**ADDENDUM No. 1**  
**FOR**  
**HURON PARK, JACK DARLING COMFORT STATIONS**  
**830 PAISLEY BOULEVARD WEST & 1180 LAKESHORE ROAD WEST**  
**&**  
**JACK DARLING EAST COMFORT STATION**  
**1180 LAKESHORE ROAD WEST**  
**PROCUREMENT NO. PRC005197**

**PROJECT No: 24-053 & 25-059**

**DATE: NOVEMBER 6, 2025**

**A101**

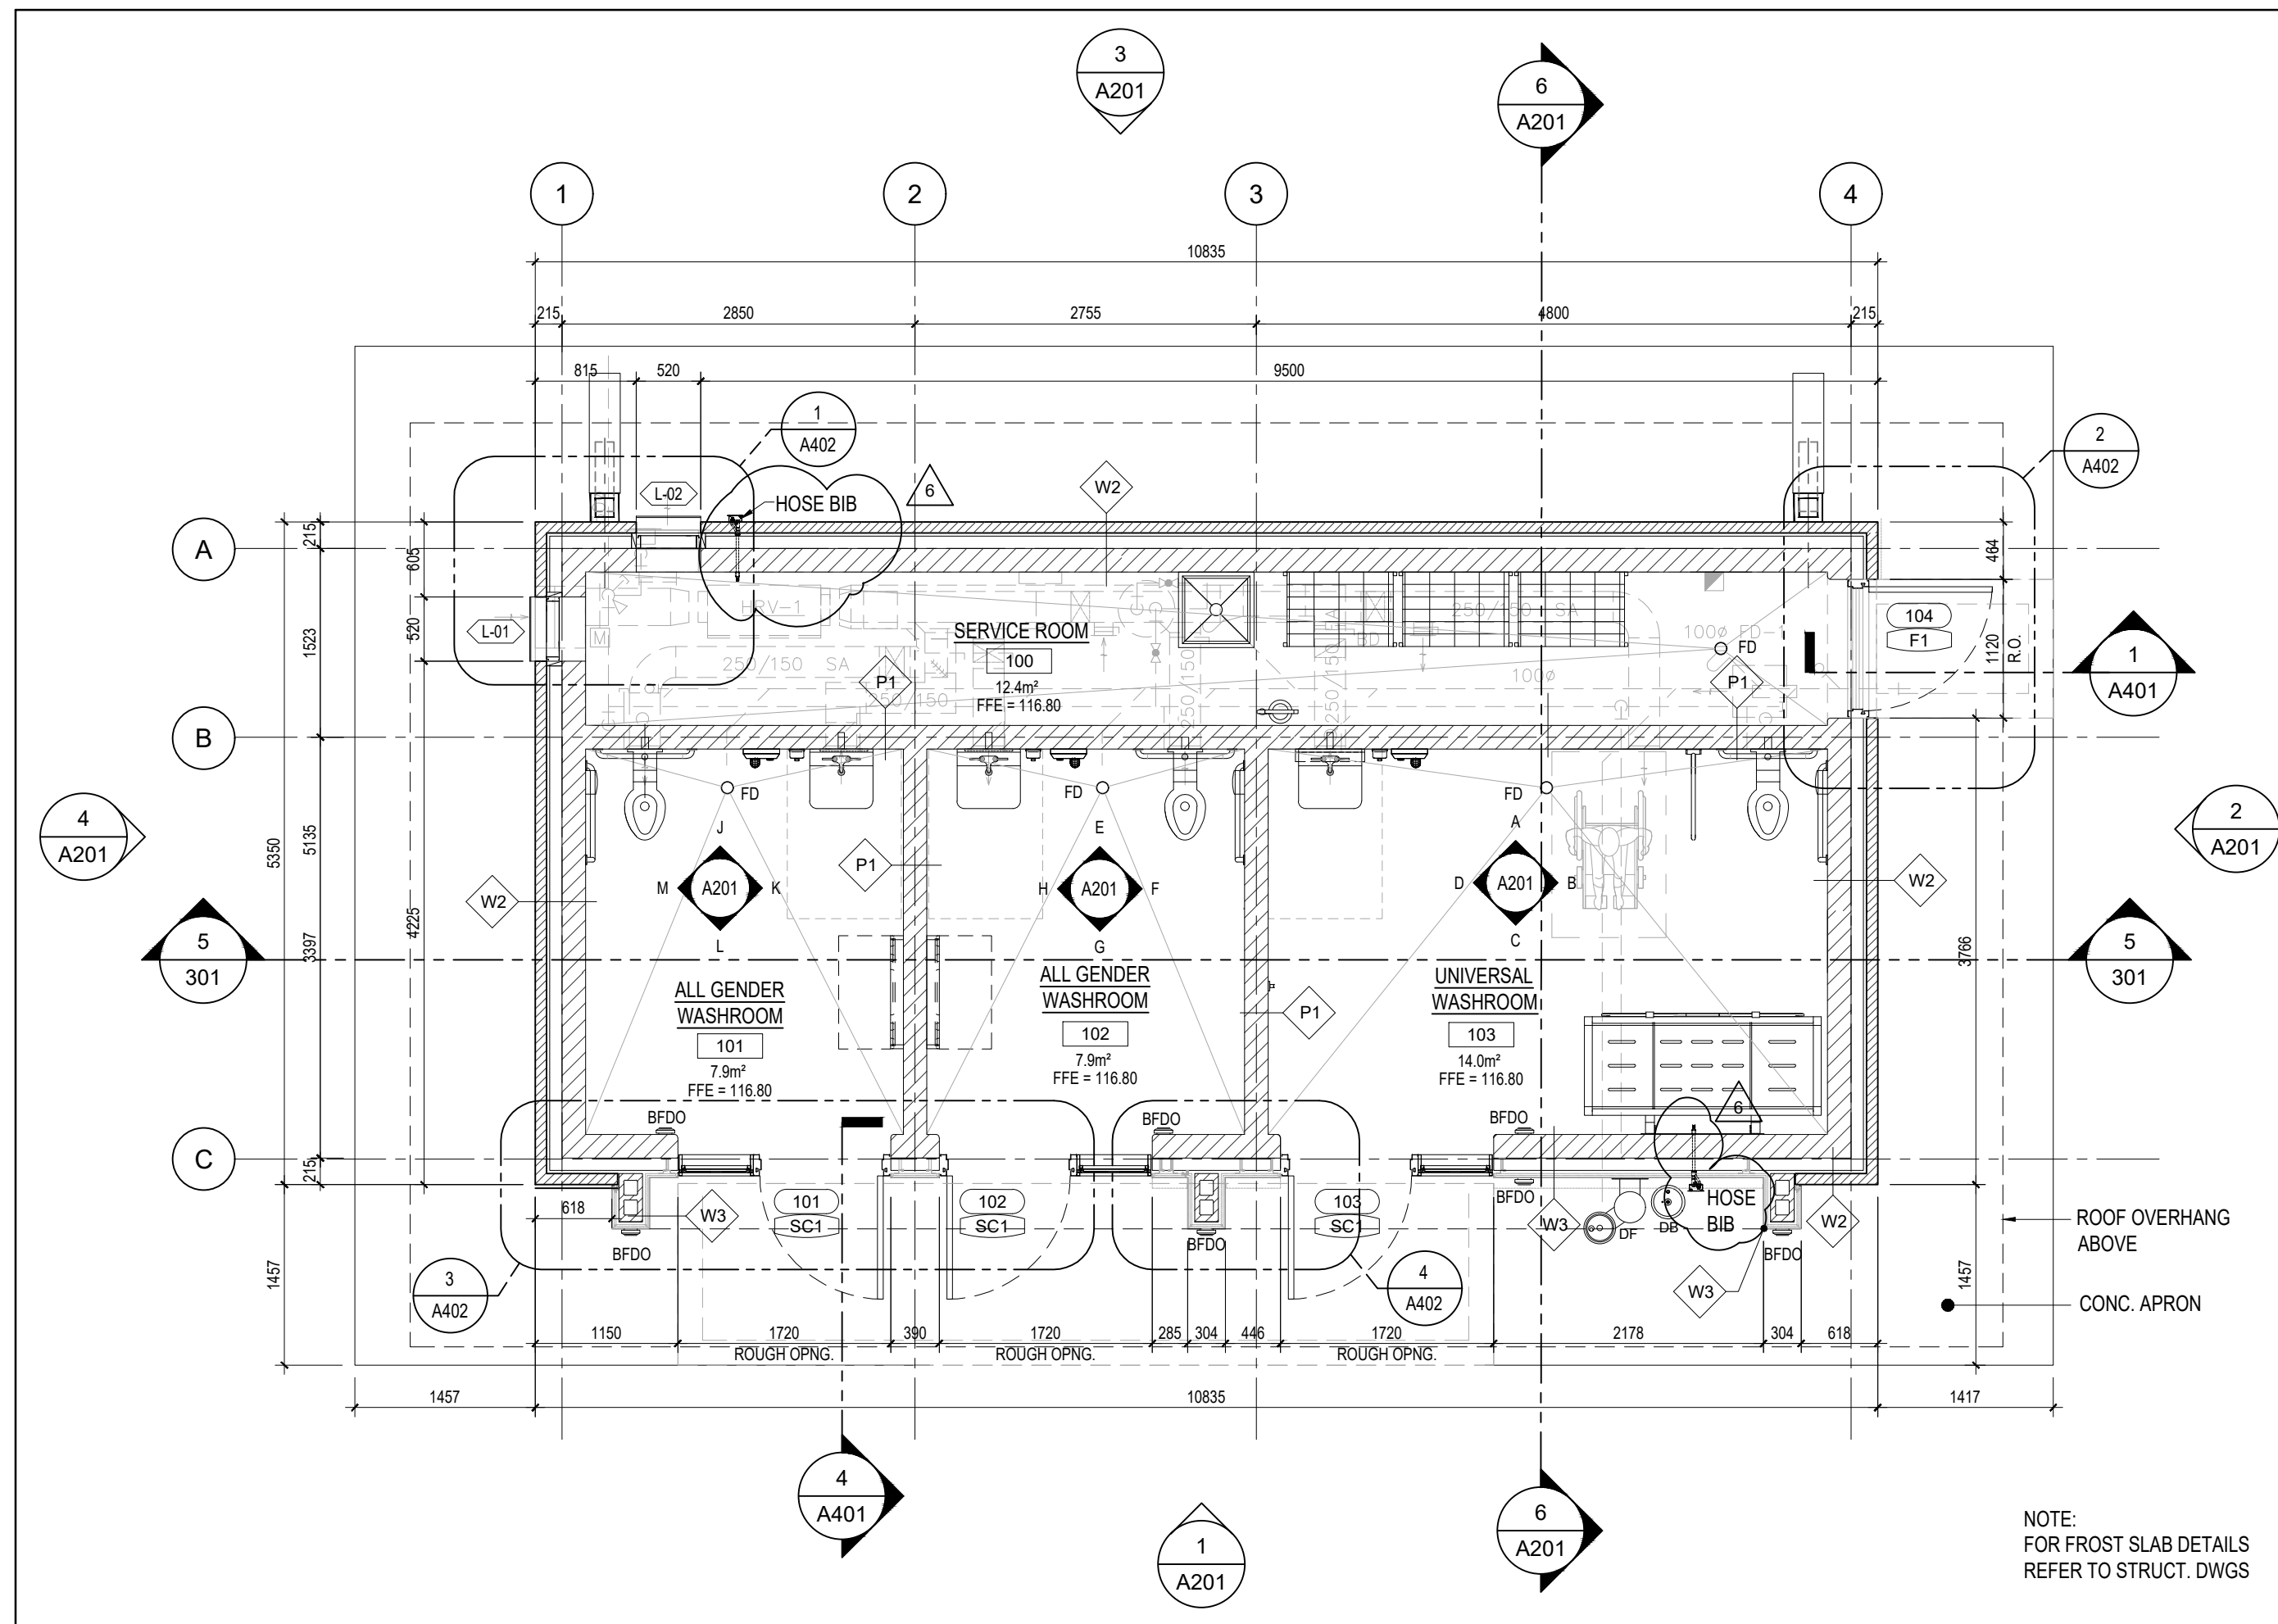
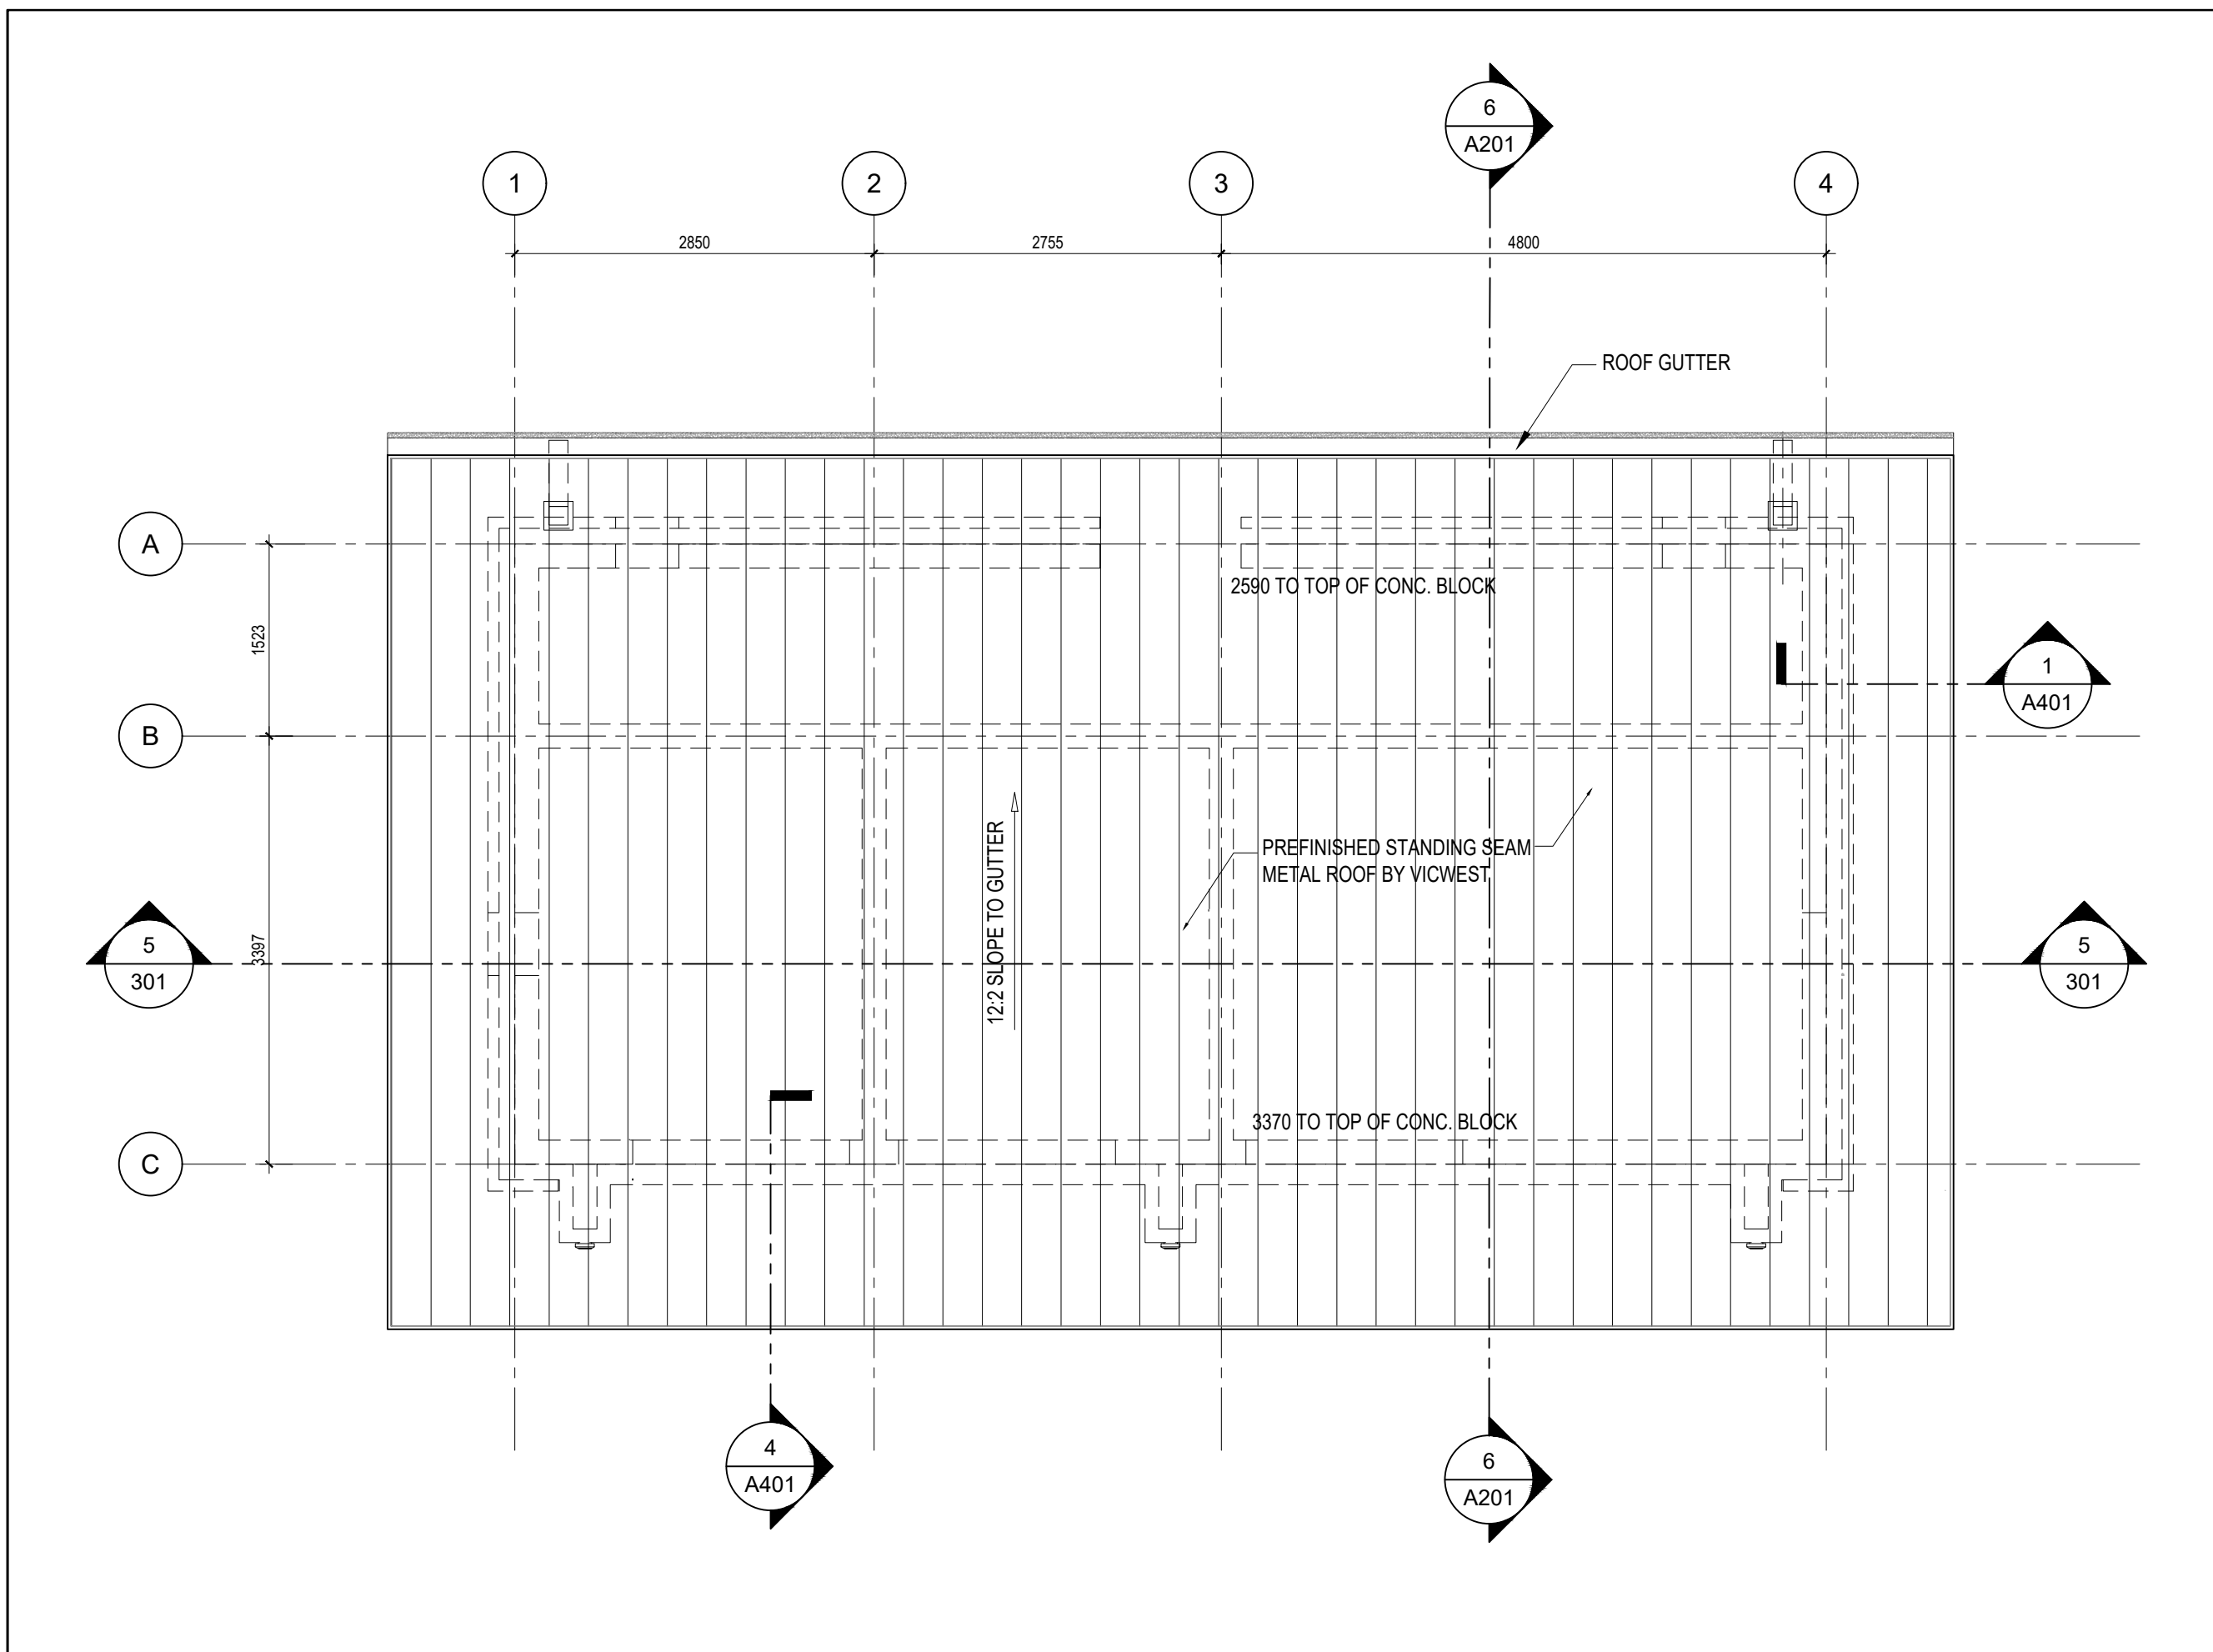
- 1.1. A-002 Revisions – Revisions to Door Frames/Screens.
- 1.2. A101 Revisions – Exterior Elevations Hose Bib locations indicated
- 1.3. A201 Revisions – Grilles and Door Frames/Screens.
- 1.4. A301 Revisions - Door Frames/Screens.
- 1.5. A401 Revisions - Louvres and lintels
